THE CITY OF KEY WEST
PLANNING BOARD
Staff Report

Application: **After-the-Fact Variance** – 3226 Eagle Avenue (RE# 00052890-001400) - A request for an after-the-fact variance to maximum allowed building coverage, maximum allowed impervious space, minimum required open space, and minimum allowed side setback in order to maintain a nonconforming accessory structure for a property located in the Medium Density Residential (MDR) zoning district pursuant to Sections 90-395,

Location: 3226 Eagle Avenue (RE# 00052890-001400)

Building Plans, 3226 Eagle Ave, submitted by applicant

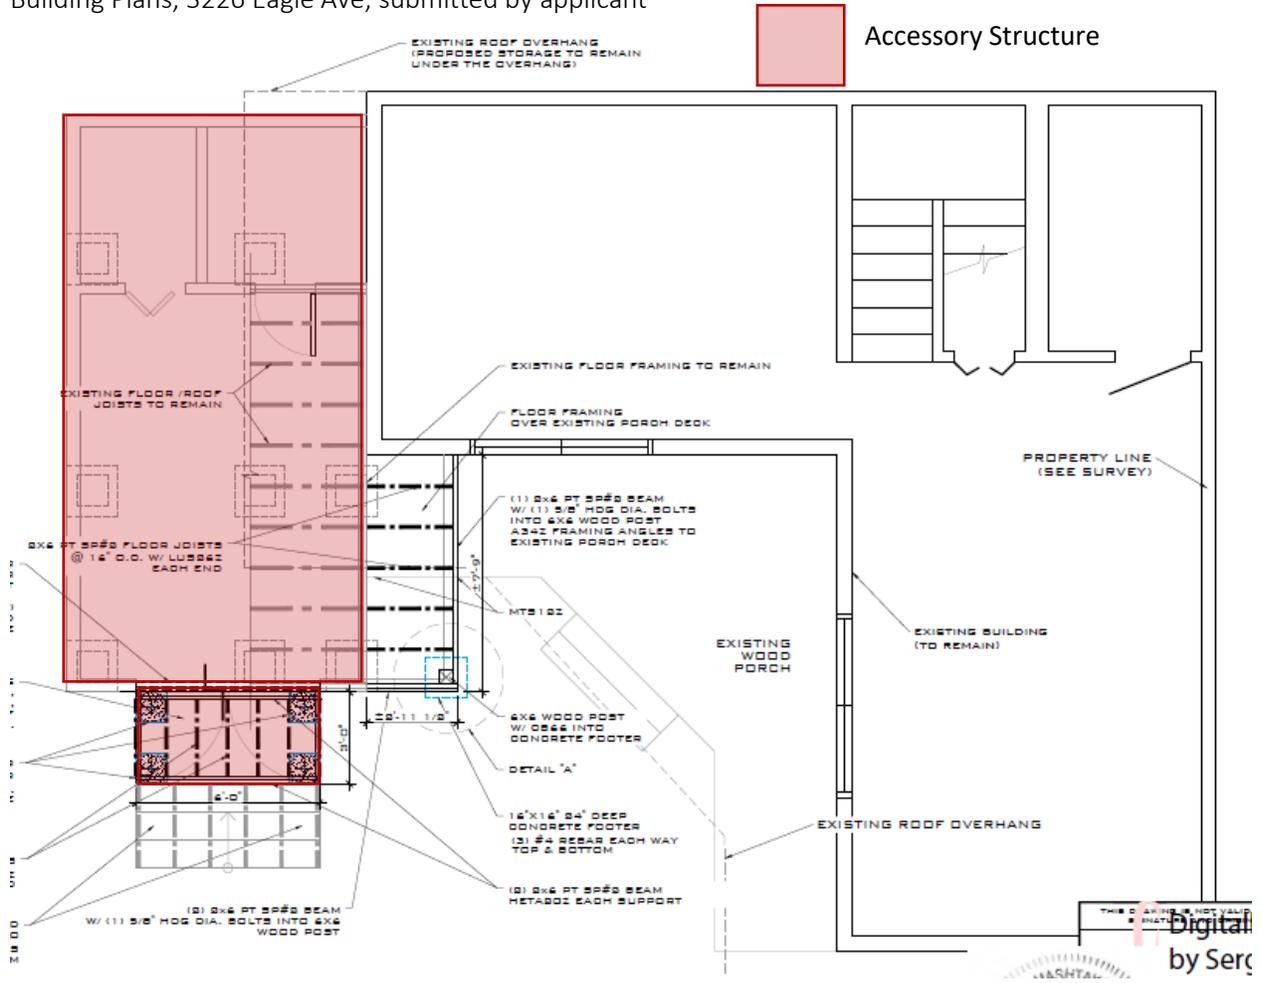
The variance is request for an existing accessory structure as shown in the plans above and the elevation below. The storage structure is 217 sqft in area and has added 145 sqft of building coverage in total.

Front Elevation, 3226 Eagle Ave, submitted by applicant.

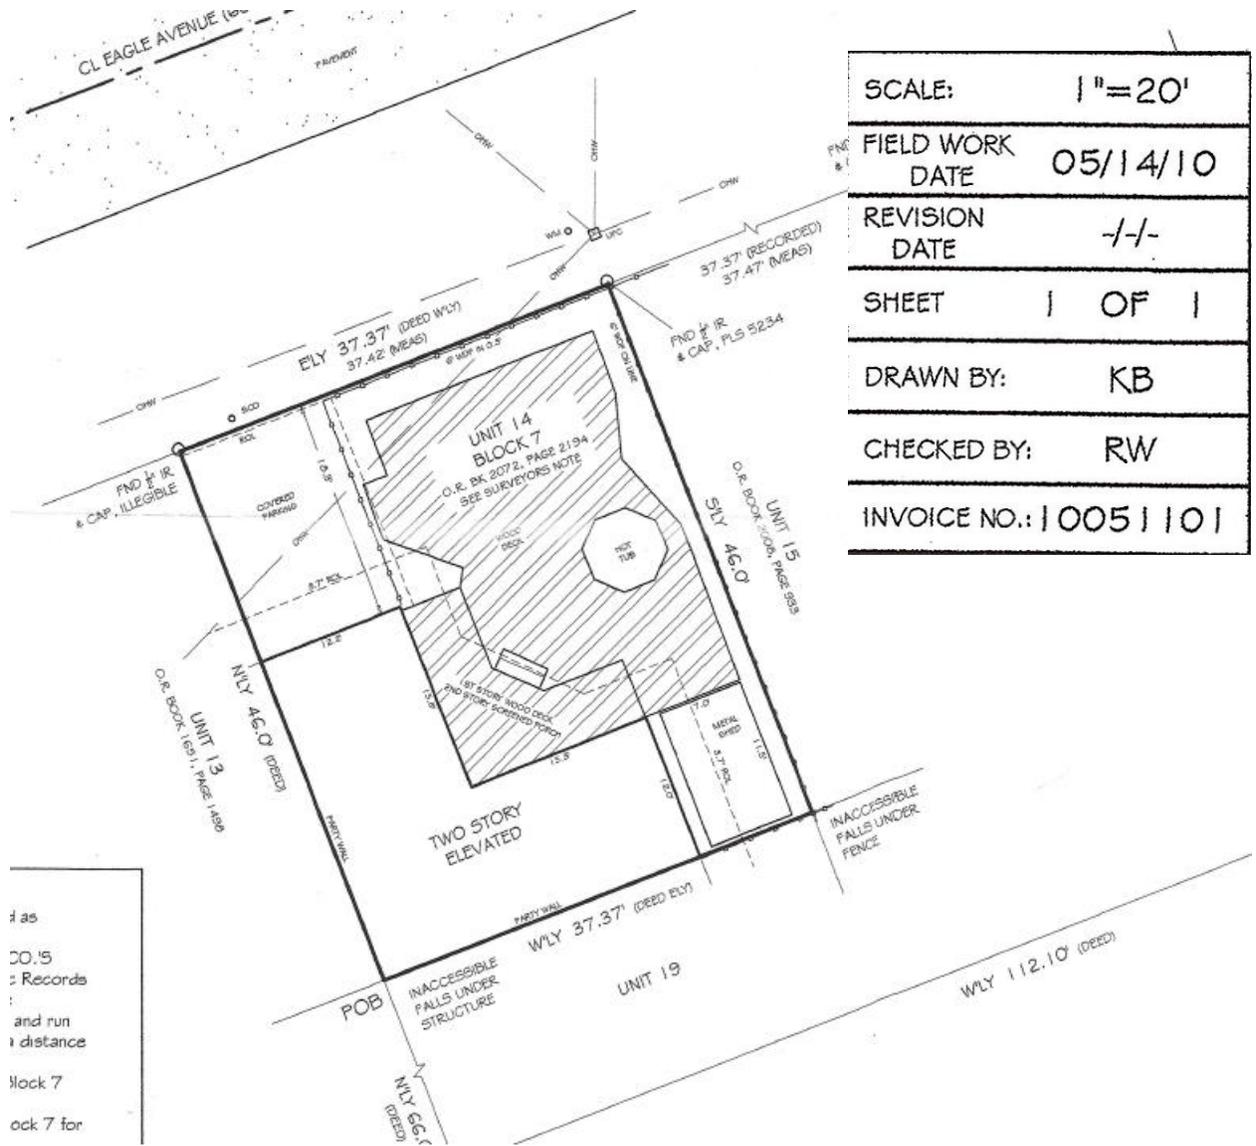
The survey below is of 3226 Eagle Avenue and shows an accessory structure in a similar location to the existing structure as far back as 2010.
